**SPECIAL MEETING - GENOA CHARTER TOWNSHIP
PLANNING COMMISSION PUBLIC HEARING
DECEMBER 4, 2024
WEDNESDAY
6:30 P.M.
AGENDA**

Attention:	Amy Ruthig, Planning Director
Subject:	Legacy Hills – Residential Planned Unit Development (Review #3)
Location:	Northwest corner of Challis and Bauer Roads
Zoning:	AG Agricultural District

At the Township’s request, we have reviewed the revised submittal from Pulte Homes of Michigan requesting PUD rezoning and conceptual PUD plan review for a single-family site condominium development (Legacy Hills) on 127.57 acres of undeveloped land situated at the northwest corner of Challis and Bauer Roads (cover sheet dated 11/1/24).

JOB NO. 231213
SHEET NO. 3
SHEET 3 OF 5

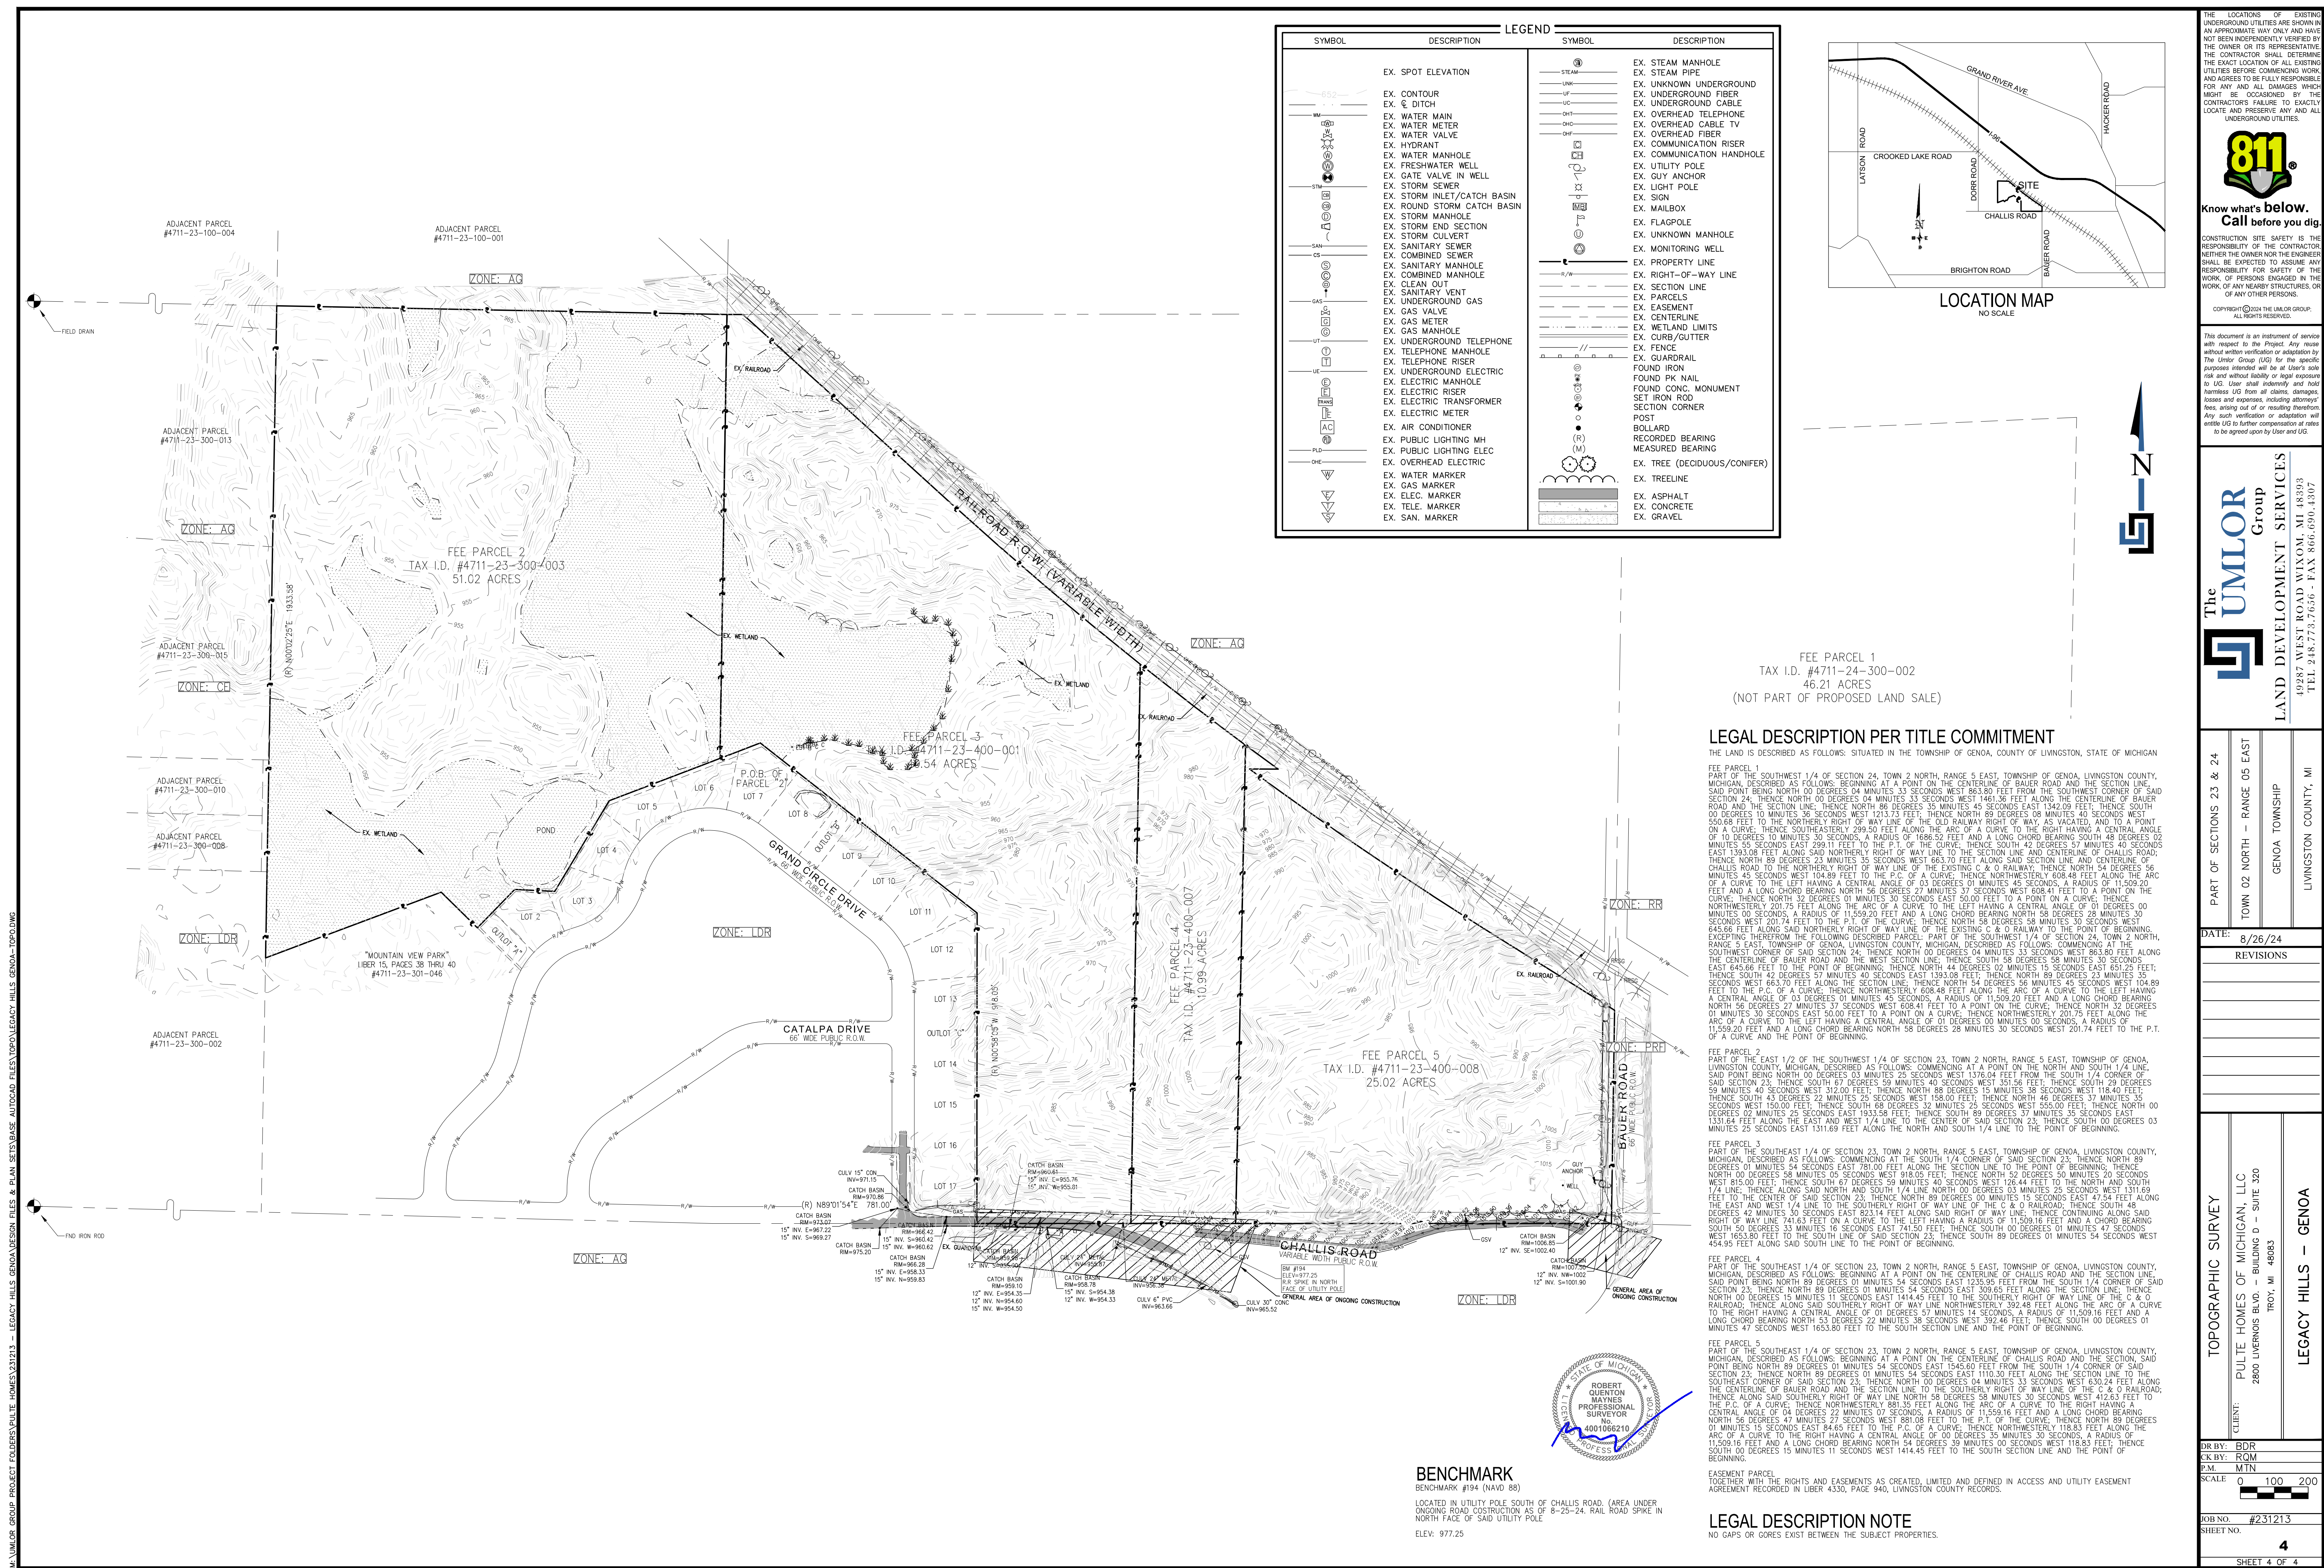
The typical unit detail on Sheet 3 depicts compliant setbacks for the front, rear and 1 side yard; however, the 2nd side yard/combination of side yards is deficient by 10 feet (20' one side and 50' combination proposed).

DR BY: SA/BB/MG
CK BY: SA/BB
P.M. MN
SCALE: 0 75 150
JOB NO. 231213
SHEET NO. 5
SHEET 5 OF 5

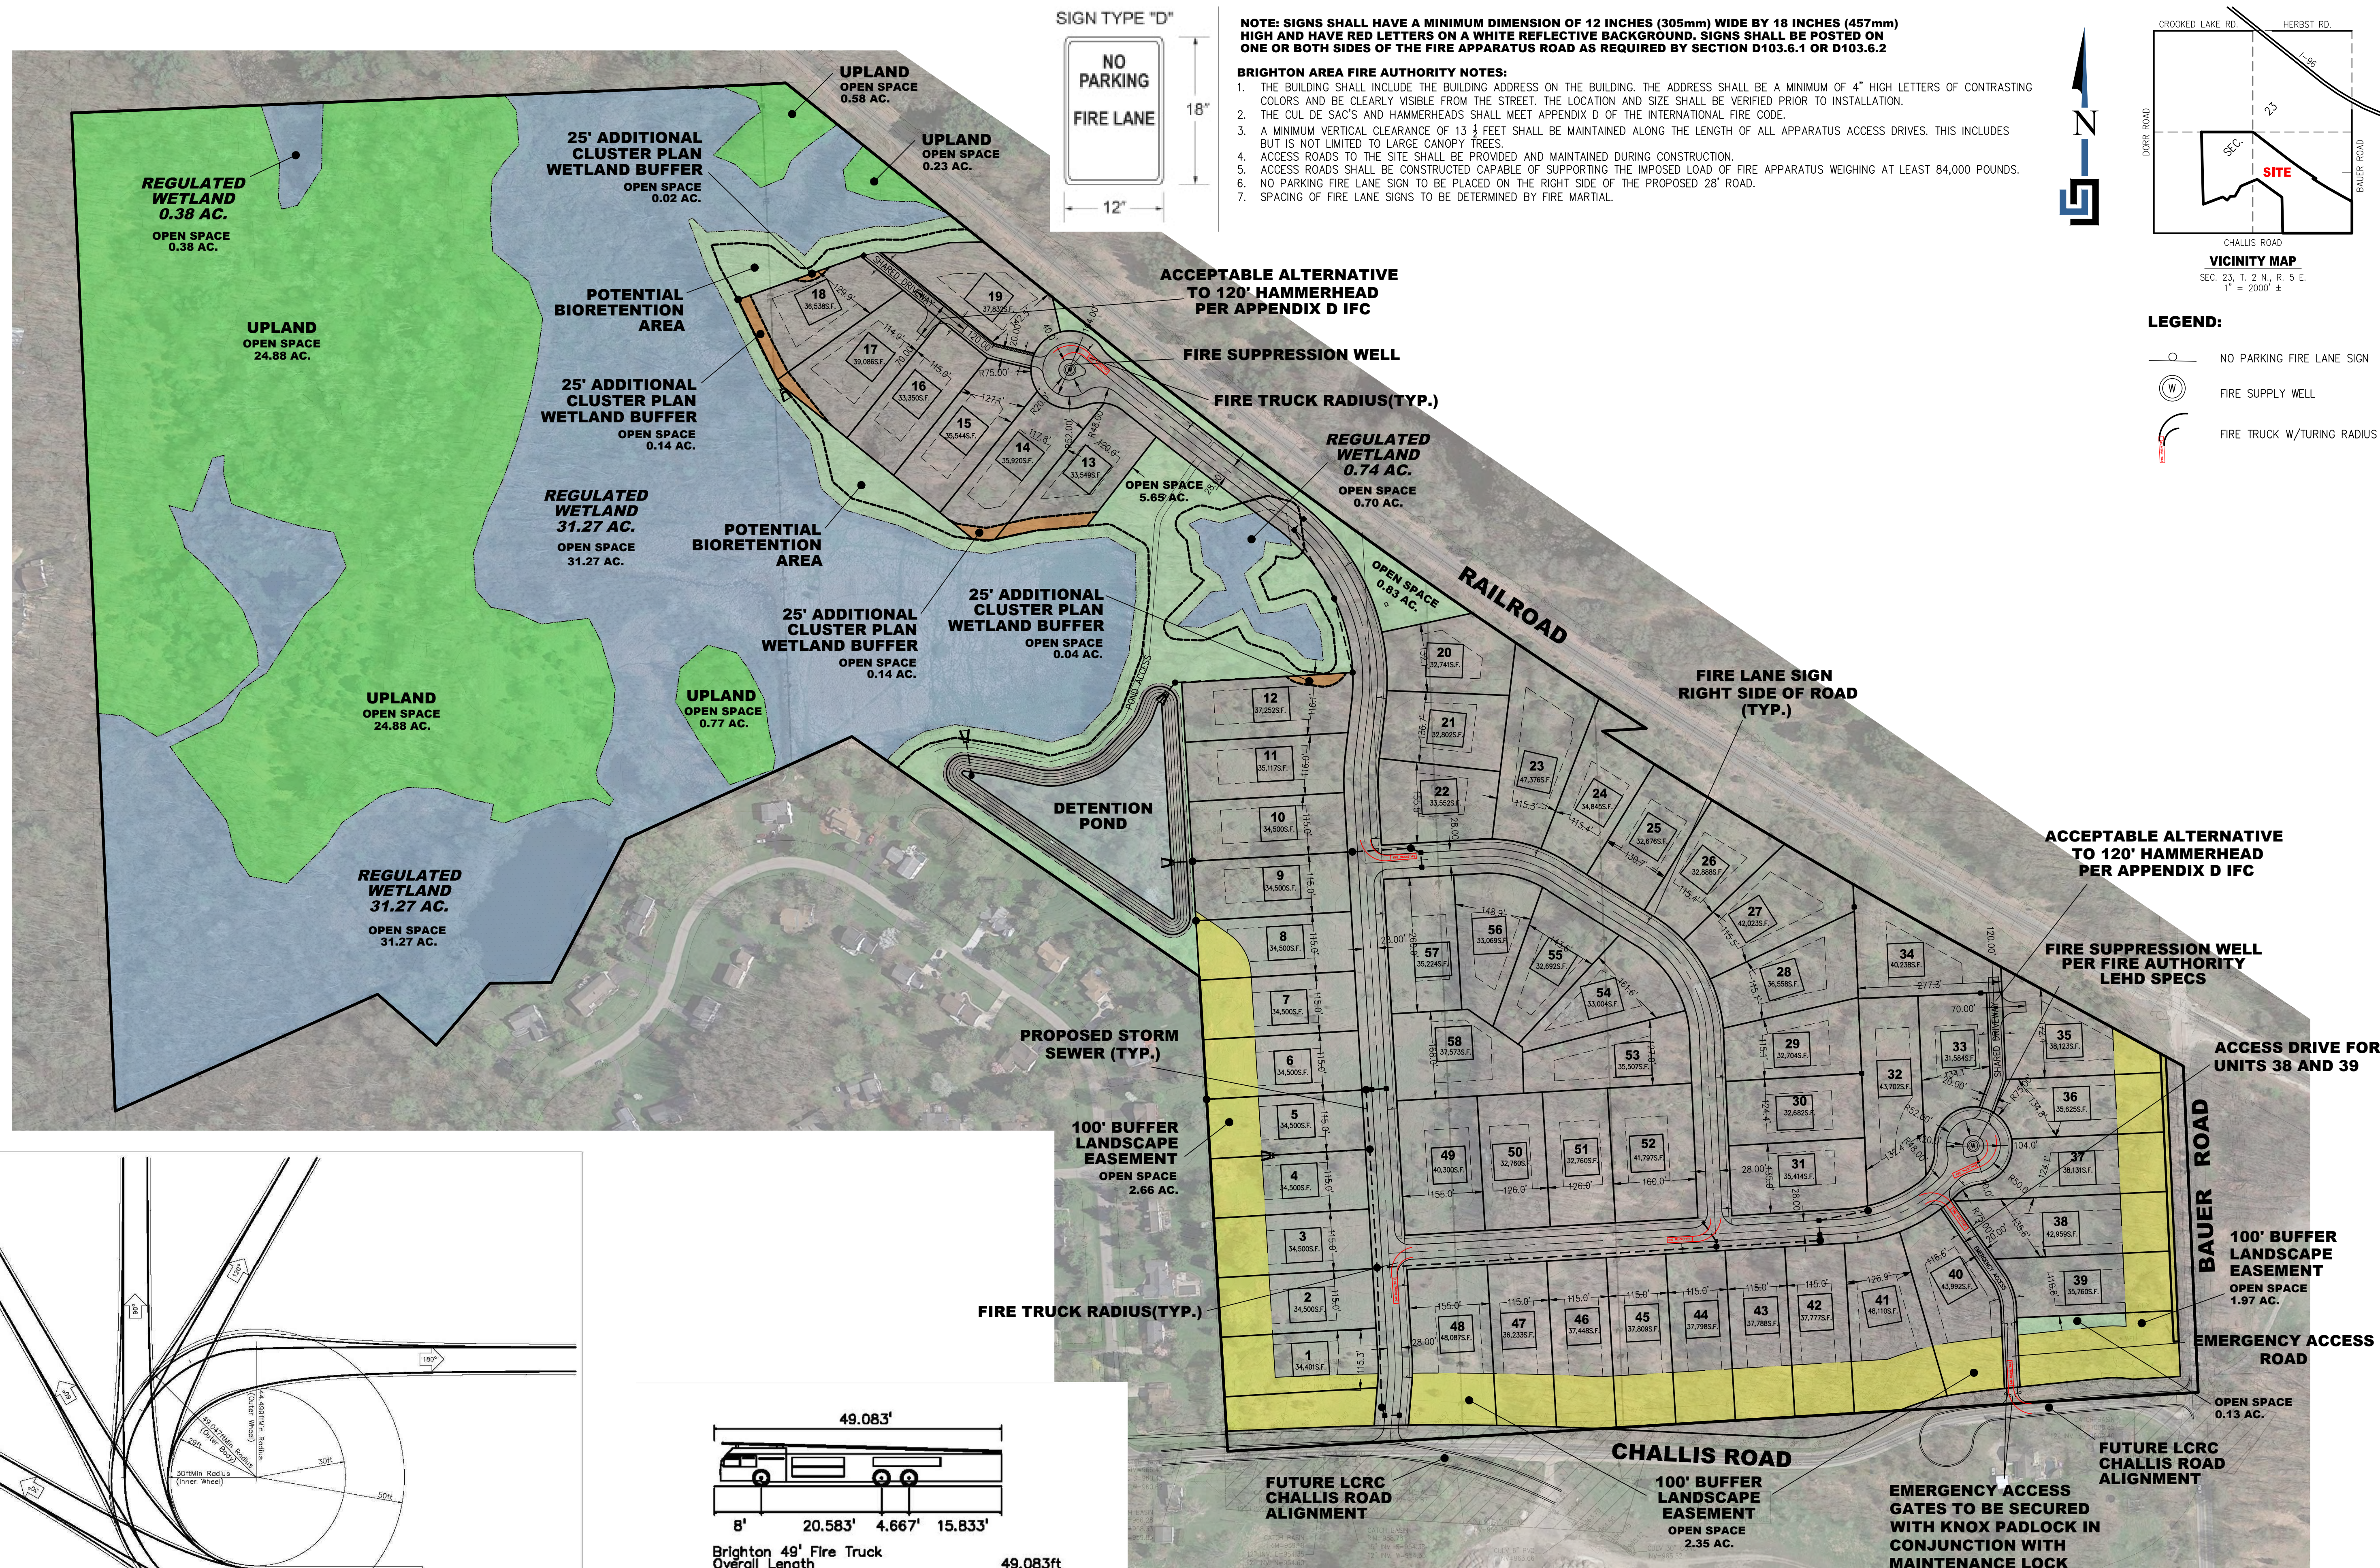
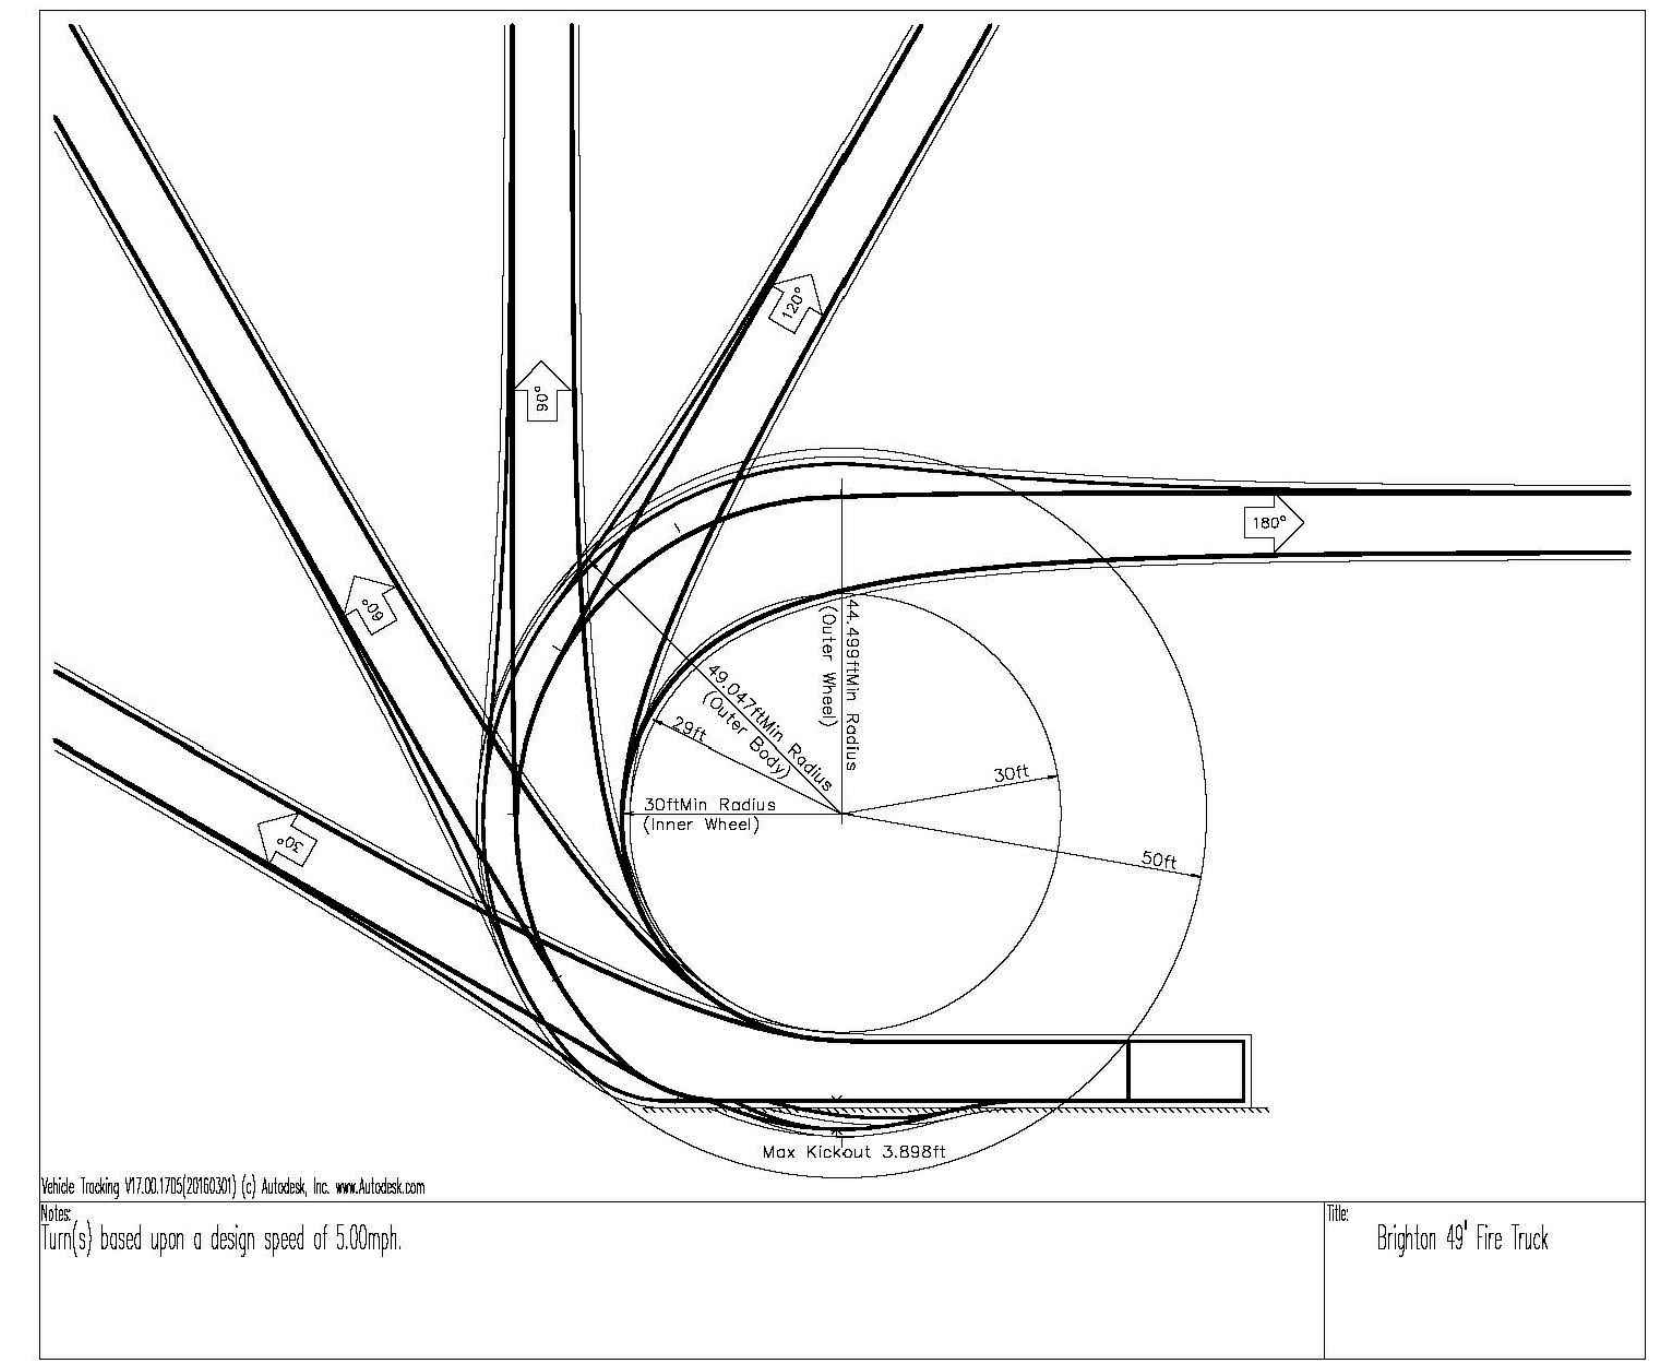
3. A minimum vertical clearance of 13½ feet shall be maintained along the length of all apparatus access drives. This includes but is not limited to porte-cochere's, lighting, and large canopy trees. The landscape plan indicates numerous large canopy trees that encroach the roadway. The trees must be setback or the species revised to prevent overhanging the roadways. **(This has been addressed by a note on Sheet 5 and the landscape plans)**
IFC 503.2.1

- 5. The building shall include the building address on the building. The address shall be a **minimum of 4"** high letters of contrasting colors and be clearly visible from the street. The location and size shall be verified prior to installation. **(This is addressed by a note provided on Sheet 5.)**

- 6. Provide additional details on the secondary access. Initial conversations stated that the access would be gated on both ends. The details shall be submitted and approved. The gates shall be secured with a Knox padlock in conjunction with the maintenance lock so the access is maintained year-round. **(Compliance with the requirement is noted on Sheet 5.)**
